**COUNTY OF SAN MATEO
PLANNING AND BUILDING DEPARTMENT**

SUBJECT: EXECUTIVE SUMMARY: Consideration of an appeal of the Coastside Design Review Committee's decision to approve a Design Review Permit and Grading Permit pursuant to Section 6565.3 of the County Zoning Regulations and Section 9283 of the County Ordinance Code, for the construction of a new 2,771 sq. ft. two-story single-family residence, with an attached 507 sq. ft. two car garage, 330 cubic yards of grading and no tree removal, on a vacant 5,230 sq. ft. parcel, located between 631 and 647 El Granada Boulevard , in the unincorporated El Granada area of San Mateo County.

County File Number: PLN 2019-00162 (Love/Zheng)

DATE: 6-24-20	DRAWN BY: CMK	CHECKED BY: AZG	REV. DATE:	REV. DATE:	REV. DATE:
GRADING AND DRAINAGE PLAN					
ZHENG PROPERTY EL GRANADA BLVD. EL GRANADA APN 047-151-120					
SHEET C-1

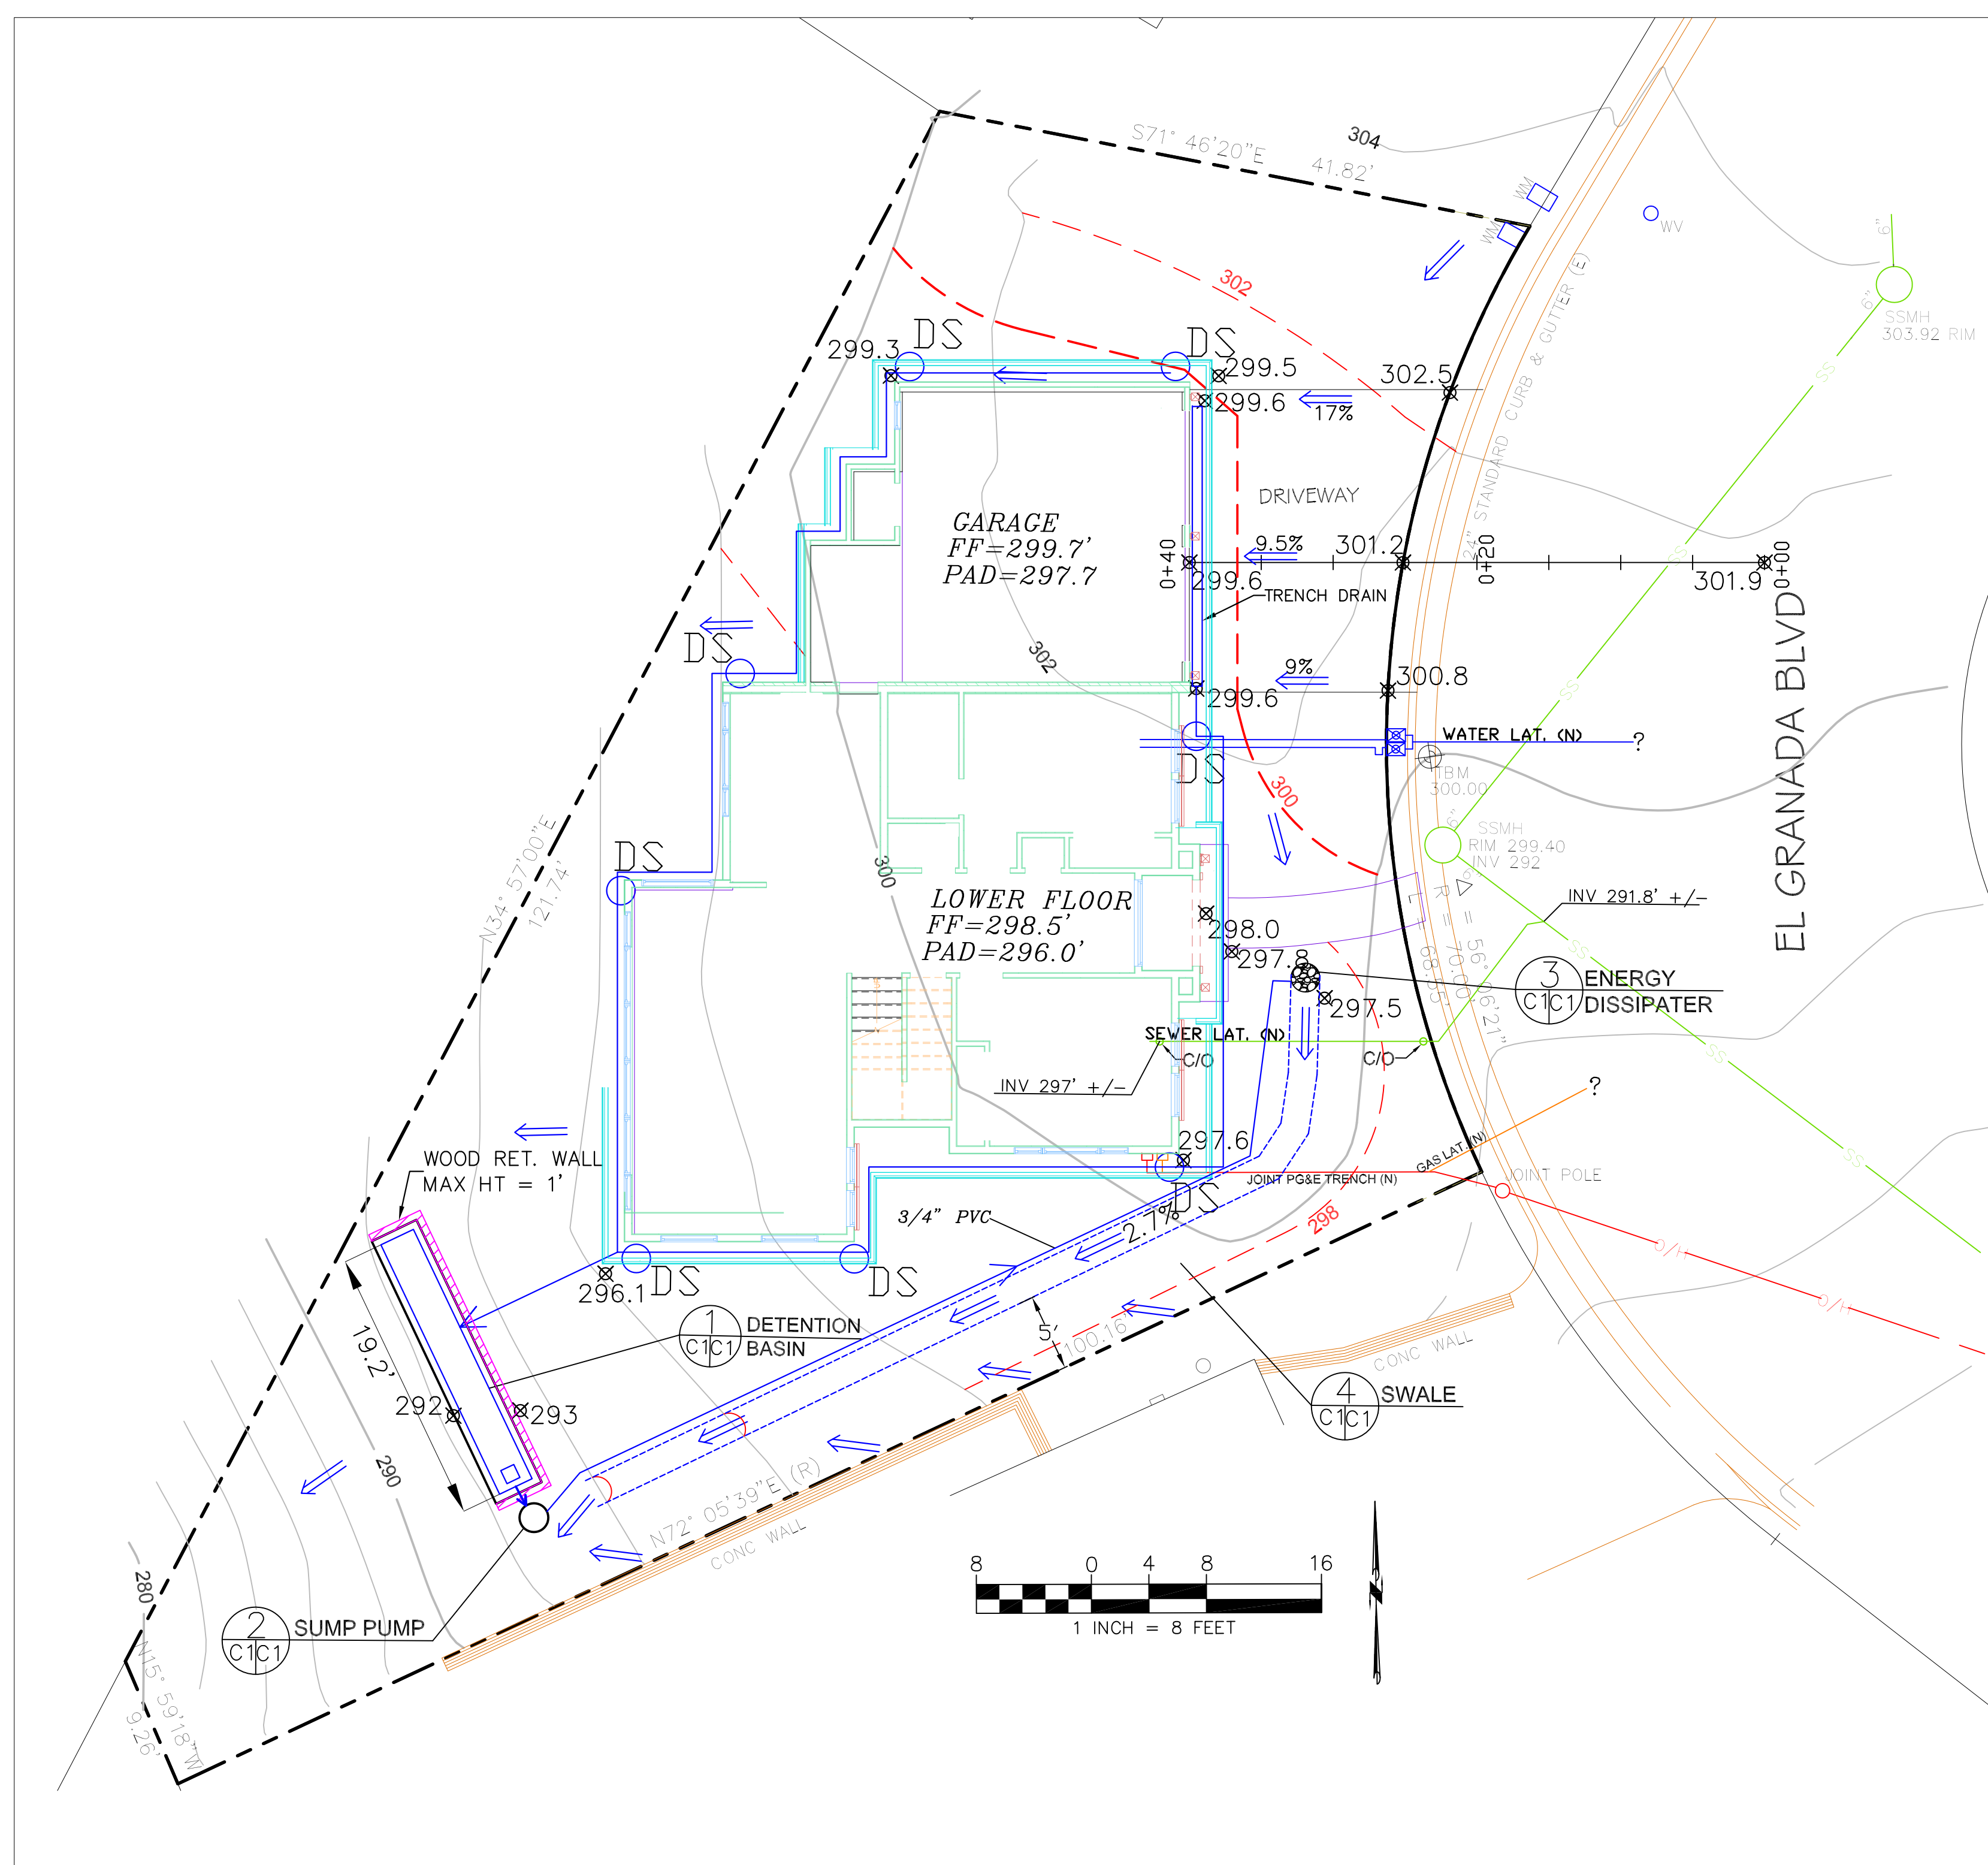
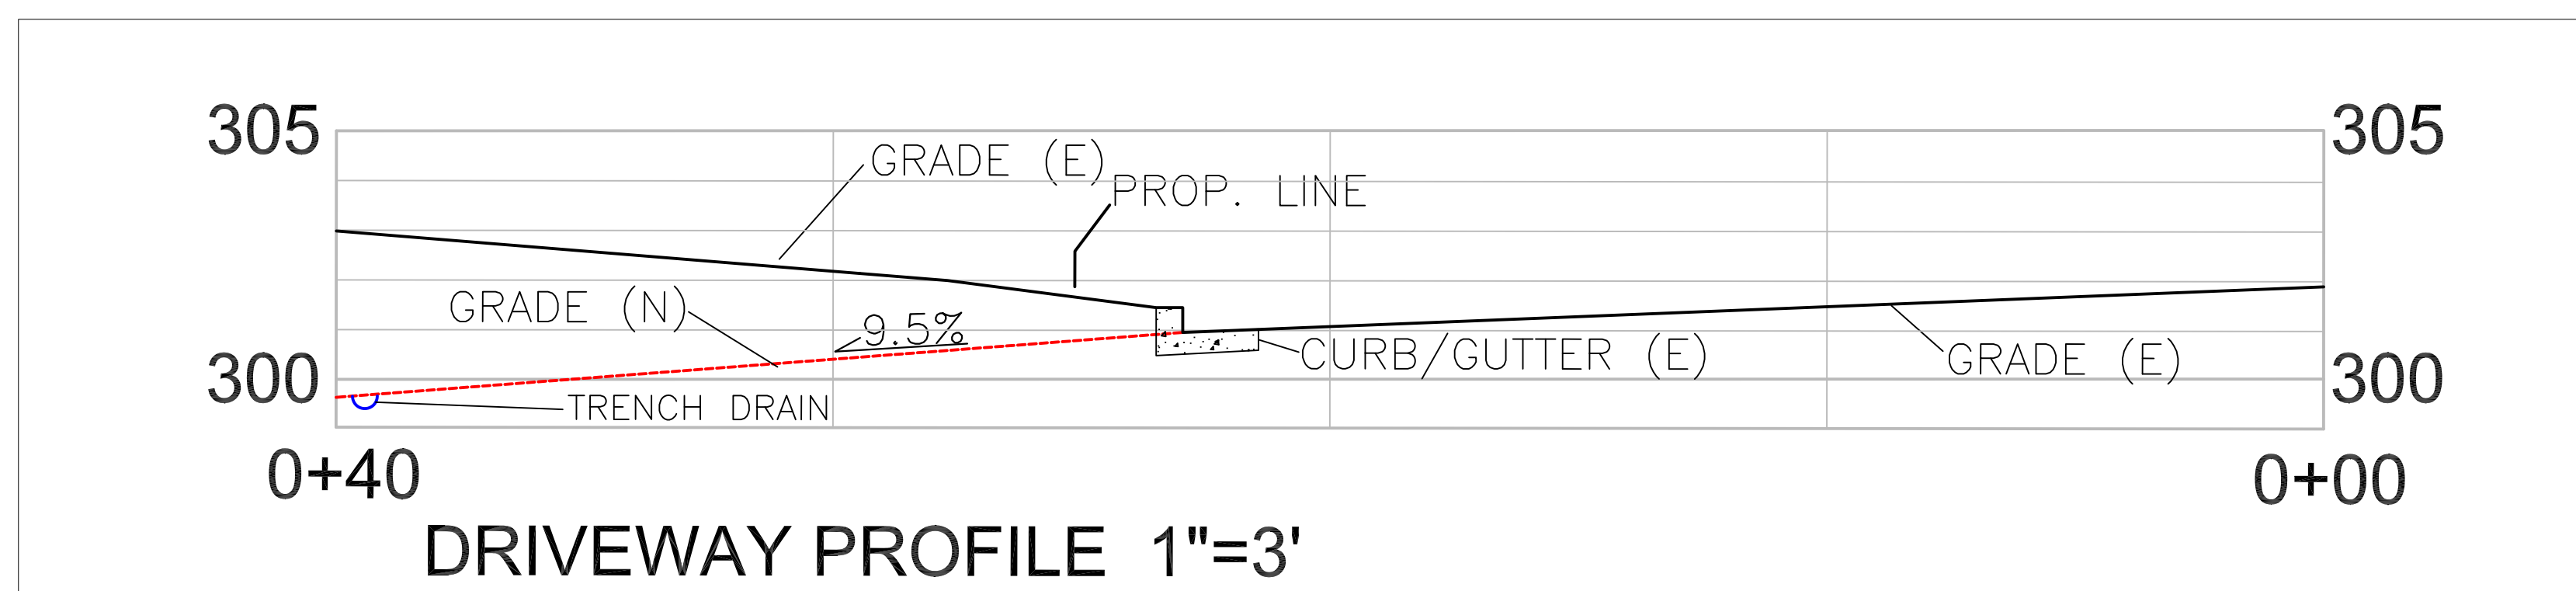
What is shown on the Second Revised Grading and Drainage Plan, sheet C-1, dated March 16, 2020 [document **R** above] is a solid 2.5 feet diameter by 13.3 feet long pipe buried in a 3.5 feet wide by 4 feet deep pit filled with gravel. No

project plans (e.g., Sheet C-1) is insufficient to comply with requisite standards. Furthermore, Mr. Zheng's design plans were significantly changed multiple times since Mr. Kissick's July 2019 report. However, the Department wrongly relied on an outdated report prepared by an unqualified engineer in order to approve the project up to this stage. The Department's May 11 Approval Letter indicates that comprehensive geotechnical analysis can *after* the project is moved past the current planning stage, but that is imprudent given that the geotechnical implications directly affect the feasibility of building a large house on a steep hillside.

Staff Response: The proposed Drainage Plan and Drainage Calculations, prepared by the civil engineer, was subsequently revised July 21, 2020, after Planning approval was issued and has been reviewed and granted conditional approval by the Building Division's drainage engineer. The revised drainage system will provide the required protection and complies with the County's drainage requirements. Further, the erosion and sediment control plan has been reviewed by drainage staff and meets County requirements.

A3.01

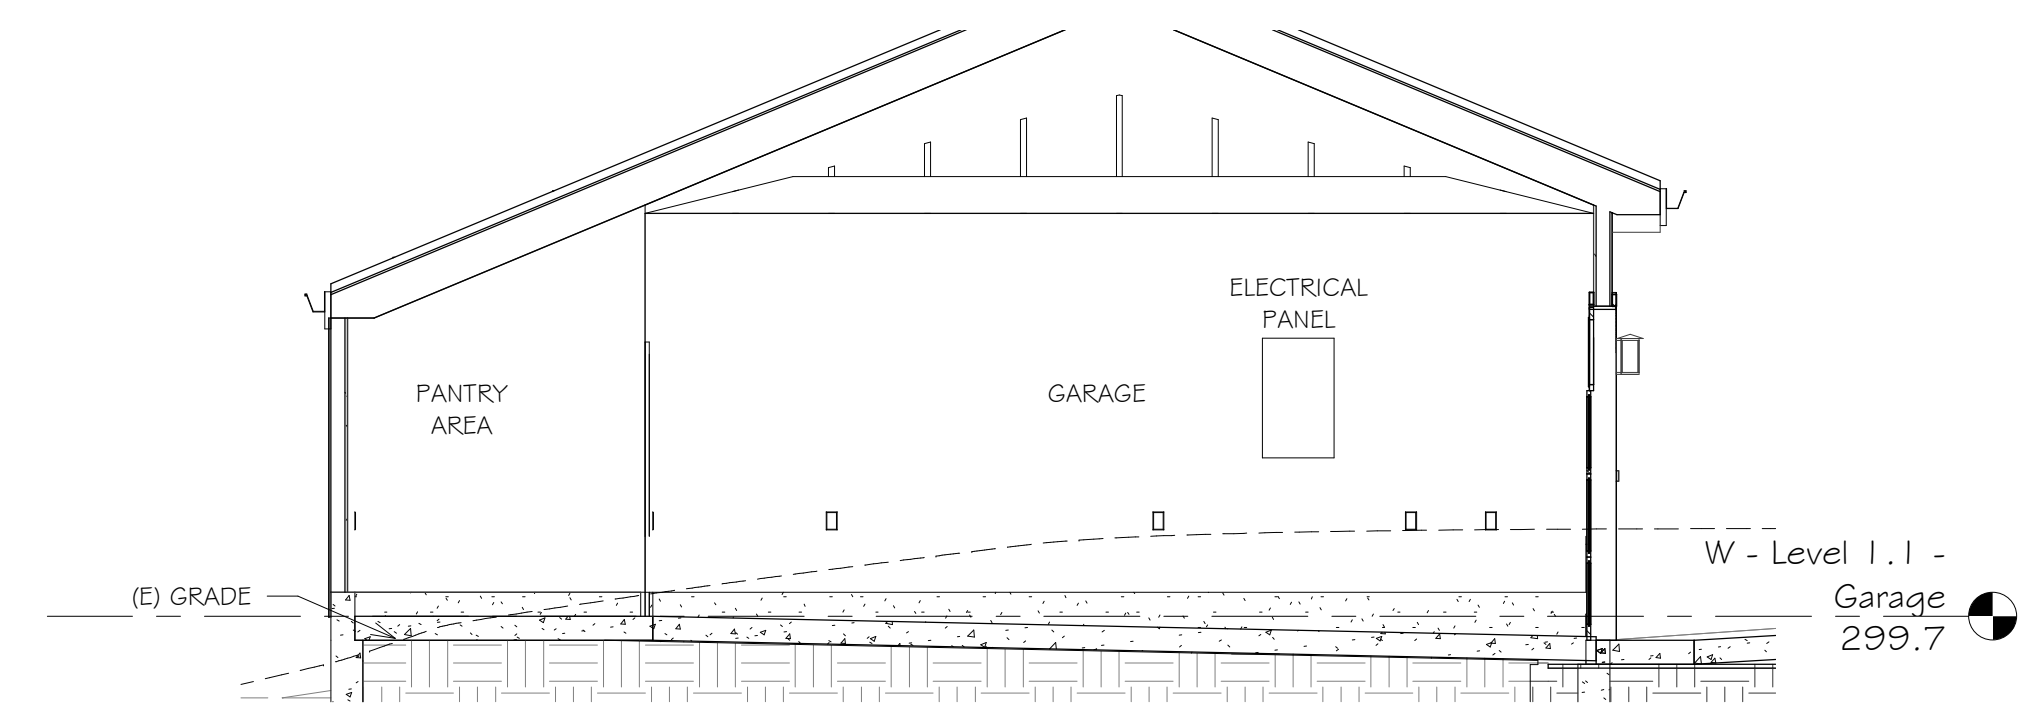
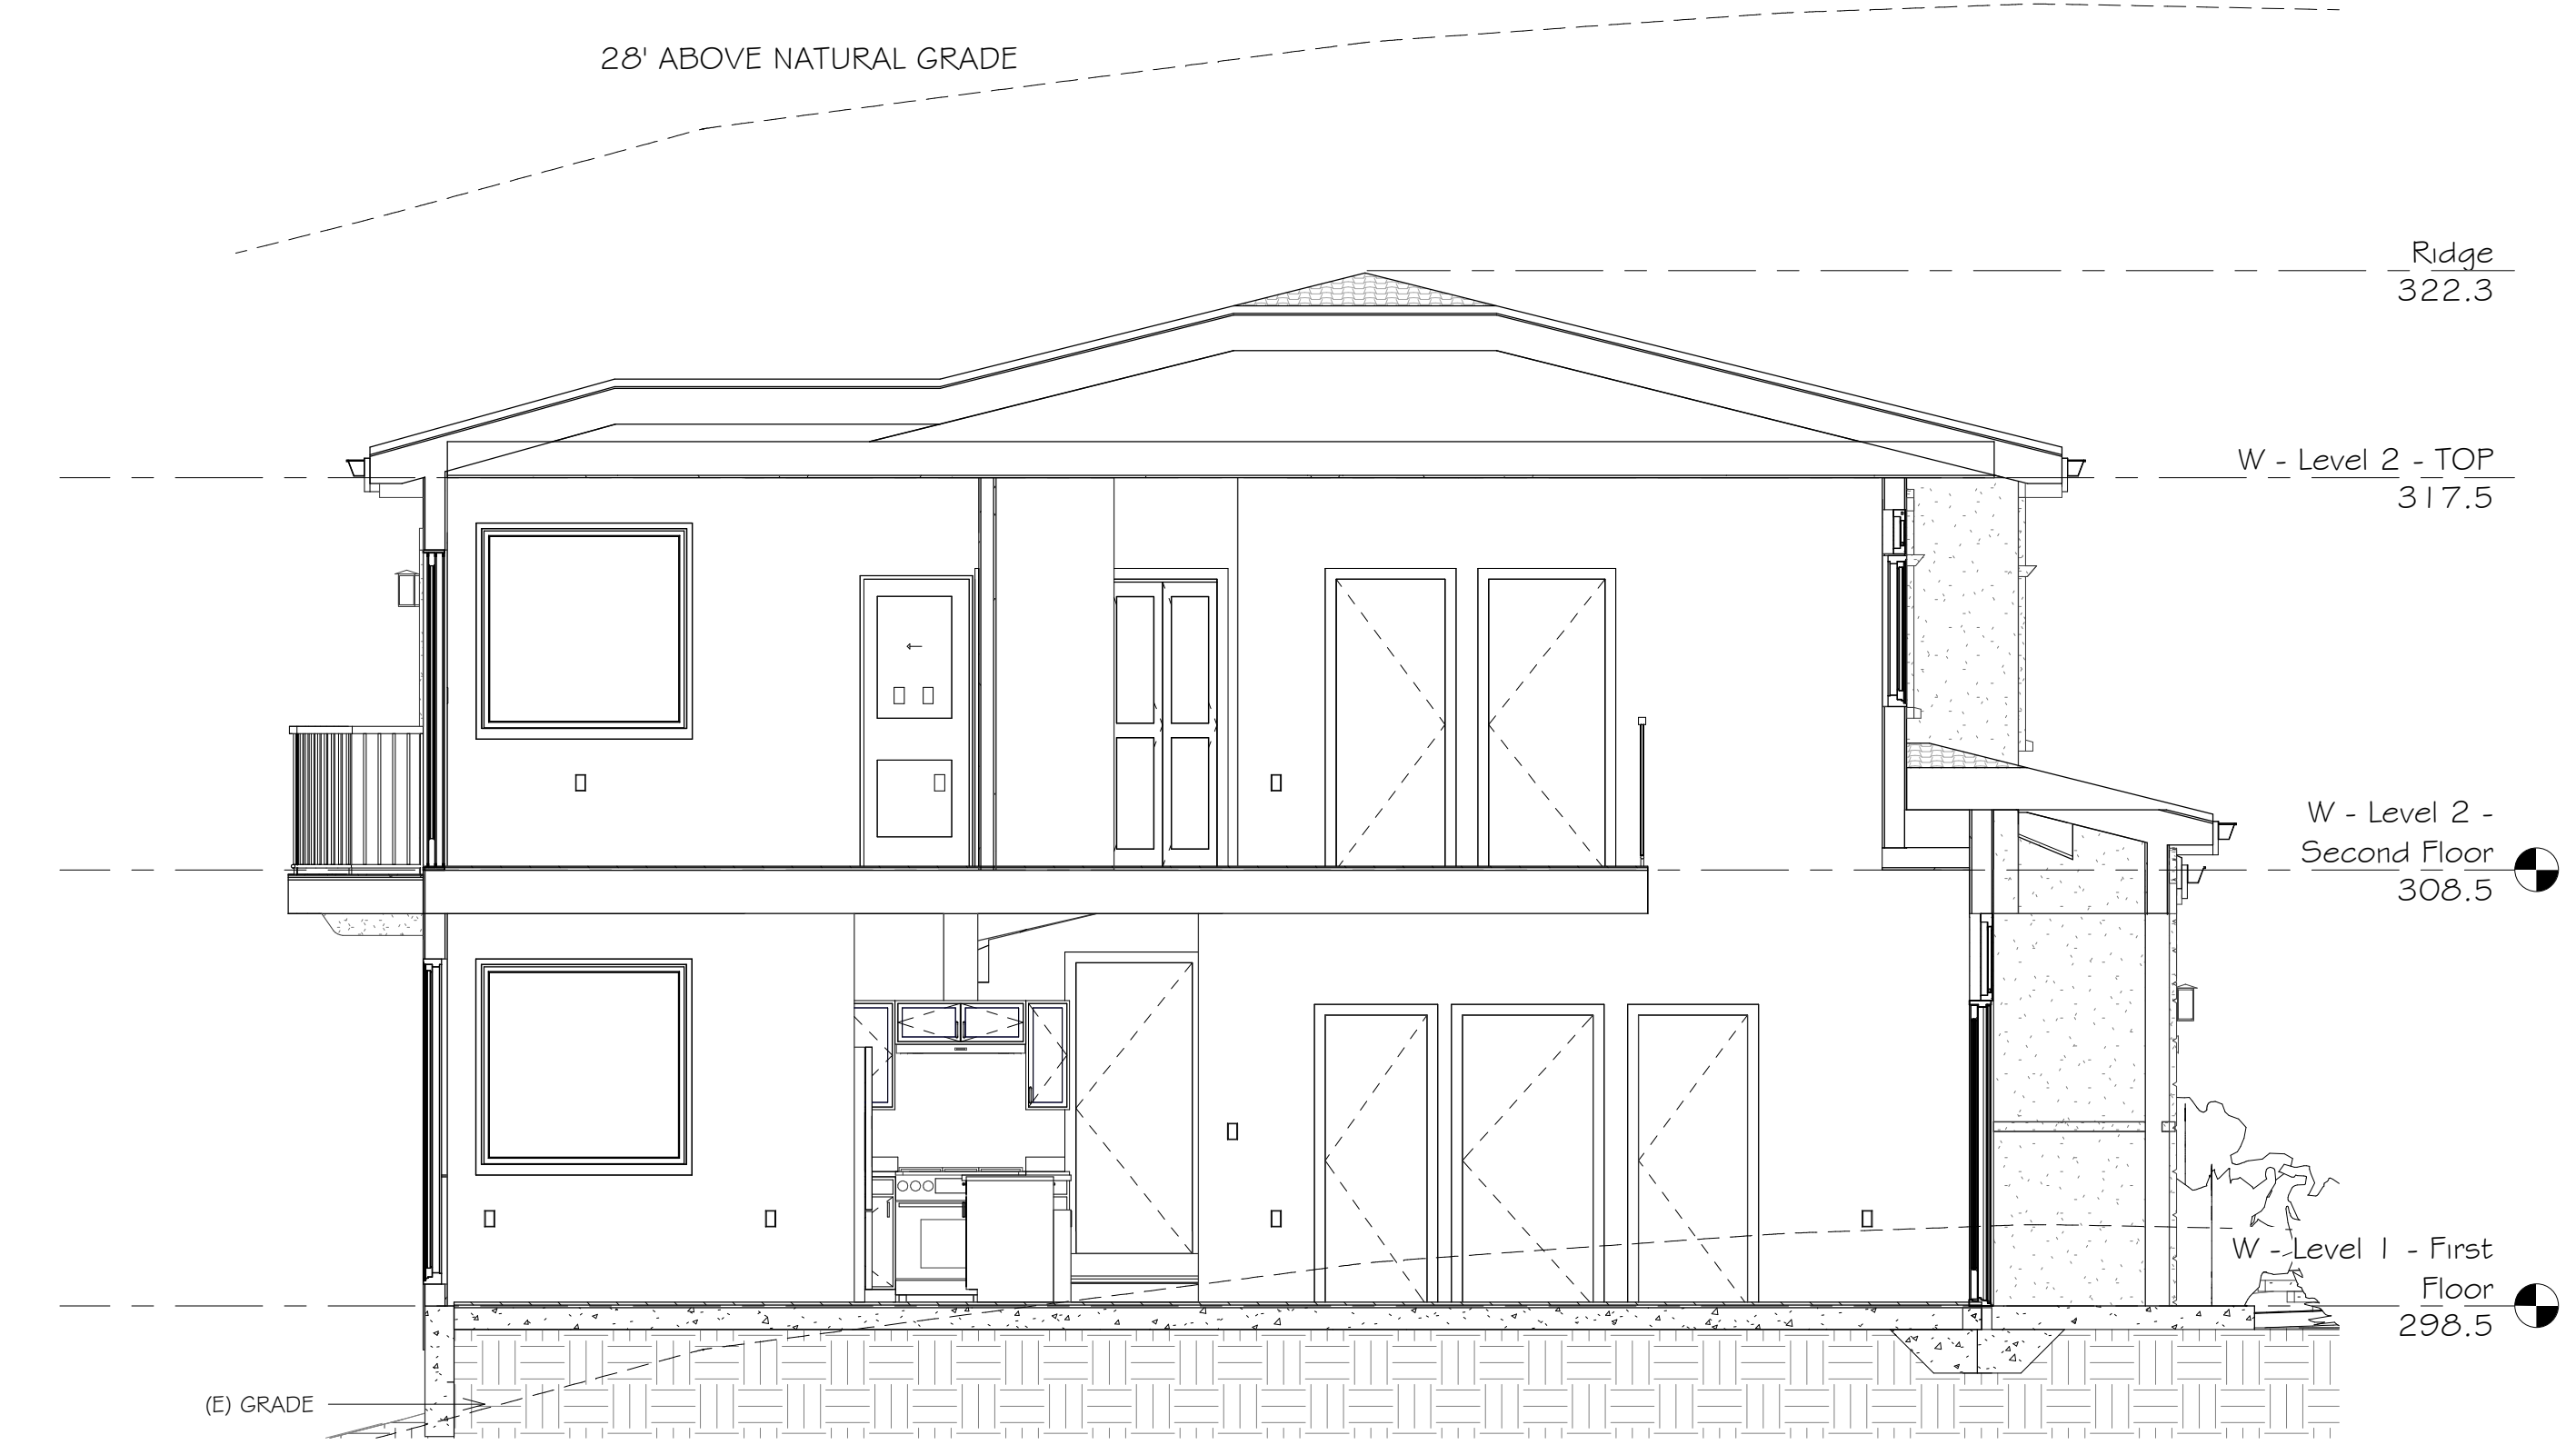
For page A3.01, Section A1 and A2, I have sketched what I am asking for ("Front to back cross section" and "side cross section"). The existing grade needs to be added to each cross section. This is how staff verifies the height.
